TSB 547
Aug. 22, 2019

TECHNICAL SERVICE BULLETIN

2020 New Aire, Mountain Aire, London Aire, Essex, King Aire (early production coaches only)

Problem: Flickering ceiling lights in early-production 2020 coaches

Installing the New Boards

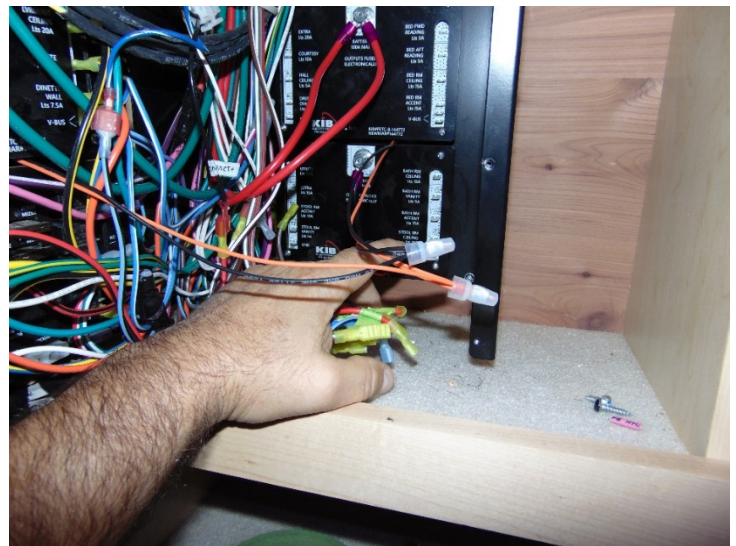
7. Hook up the wire(s) with the ring terminals that were removed when taking off the circuit board. Using a backer wrench, tighten the nut with a nut driver or socket and ratchet.

- o Caution: Do not over tighten the nuts, as damage to the circuit board may occur.
 - o Note: A backer wrench cannot be used on the back two boards if they are mounted before the wire(s) are connected.

8. Install the center screw, and align the other screw holes before tightening.
 - o Caution: Do not over tighten the screws, as damage to the circuit board may occur.
